Service Bulletin

Service Bulletin No. 1

SUBJECT: TAIL BRACE STRUT

MODELS AFFECTED: CHRISTEN A-1 HUSKY S/N's 1001 THRU 1085

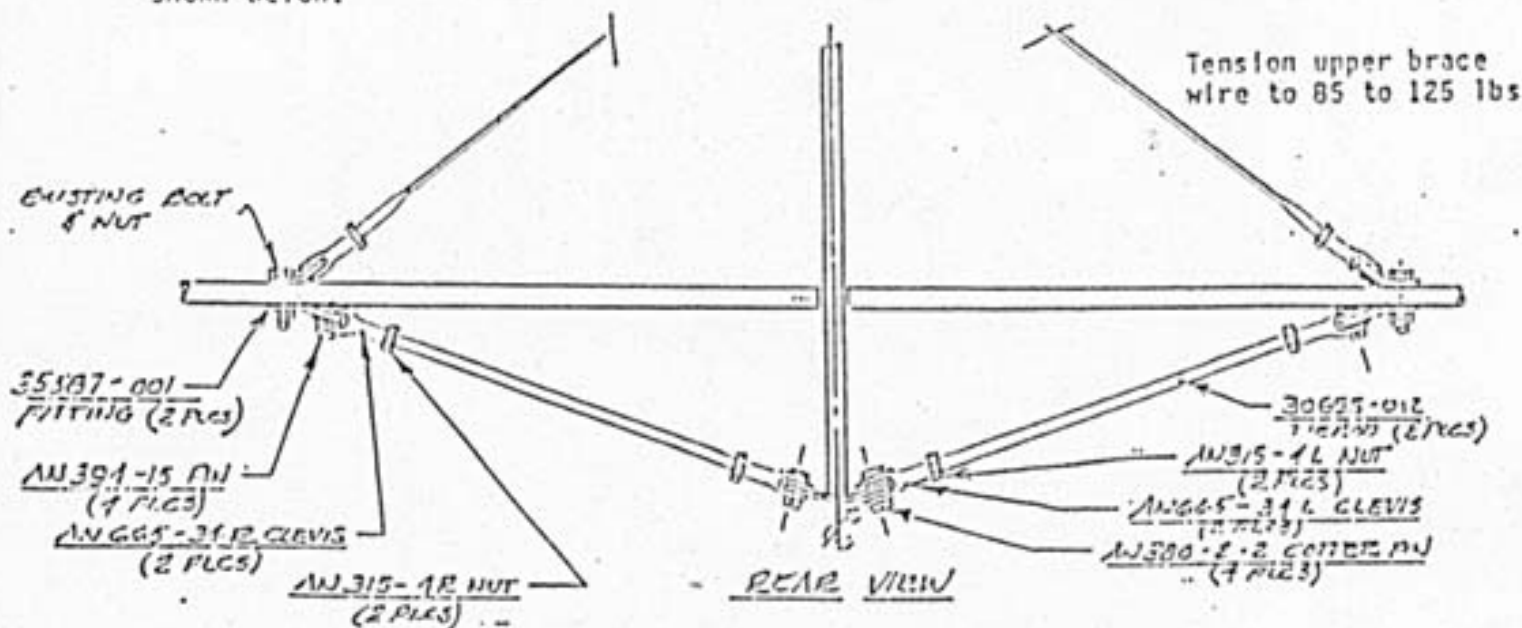
There have been several instances where the lower left rear tail brace strut has failed in the threaded stud welded in the inboard lower end of the strut.

For this reason, it is requested that the lower end of each rear stabilizer strut be visually inspected before each flight for any cracks in the threaded portion of the strut fitting where it screws into the terminal end.

In order to preclude the possibility of this type of failure in the future, please replace both rear lower struts with 1/4" dia. stainless steel tie rods as shown below:
